ADDENDUM NUMBER 6

DATE: March 29, 2017  
PROJECT: Requa Community Water Distribution System  
OWNER: Yurok Tribe  
ENGINEER: Altec Engineering  
TO: Prospective Bidders

## Bid Questions, Answers and Clarifications

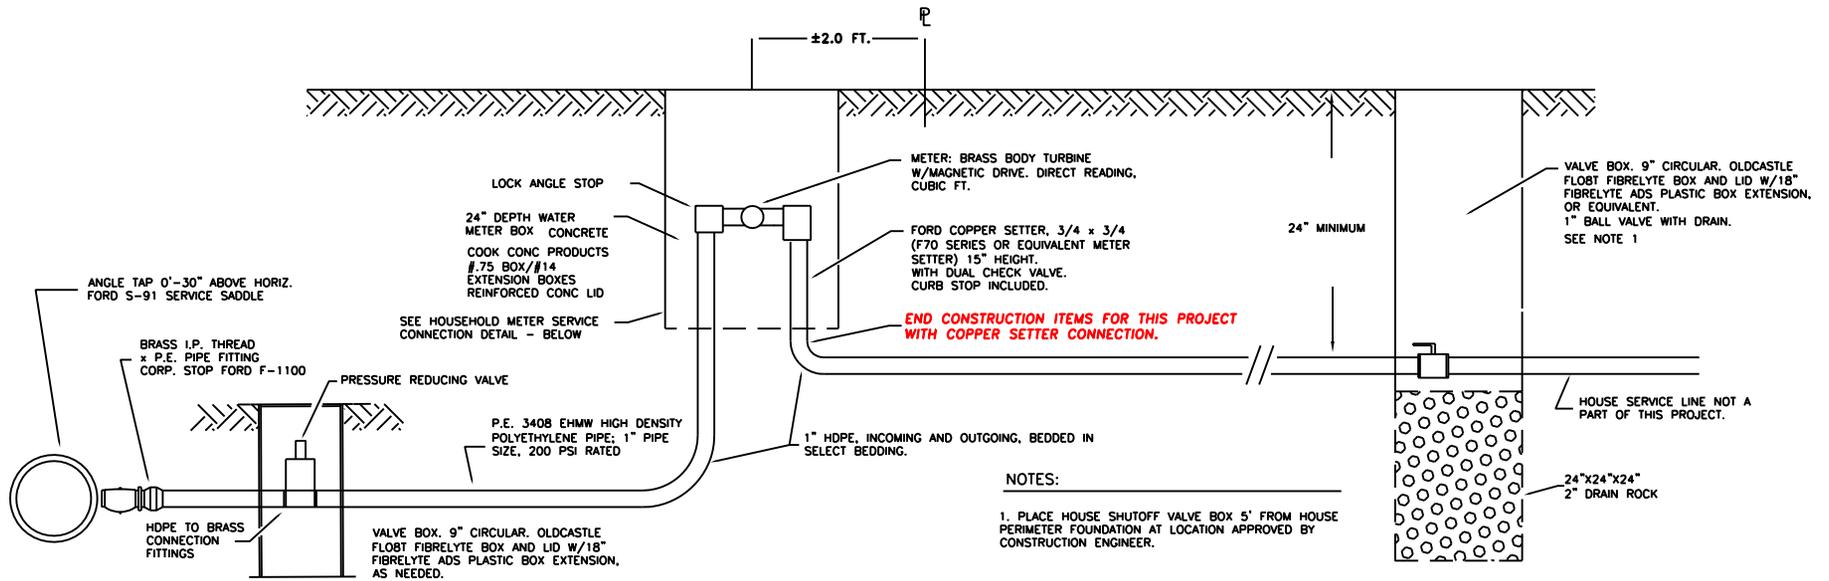
5) **Question:** Should the piping materials that is shown on sheet c 202 that runs between the A1 line and the booster pump be covered in the booster pump bid item?

**Answer: Yes. It's all open trench and isn't included in the stationing.**

WATER SERVICE DETAIL  
NOT TO SCALE

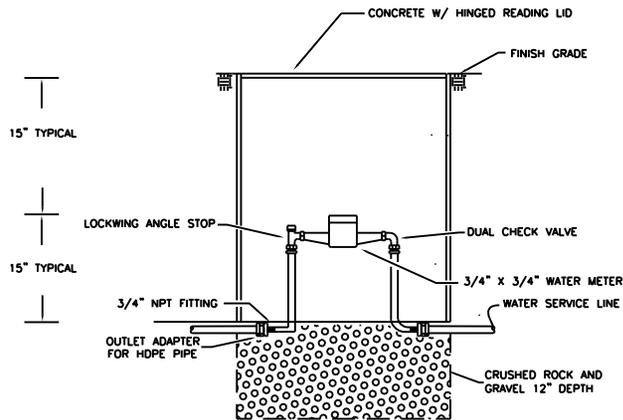
7) **Question:** Items 32 and 34 are not shown on the plans and have no details. What exactly are you going to require? Would item 34 be the flush hydrant?

**Answer: See attached Water Service Detail and Meter Service Detail. Hydrant detail is shown on C 503. Blow-off is shown on C 504. Technical specifications for the bid items are shown in Bid Package Technical Specifications 02518.**

1. PLACE HOUSE SHUTOFF VALVE BOX 5' FROM HOUSE PERIMETER FOUNDATION AT LOCATION APPROVED BY CONSTRUCTION ENGINEER.
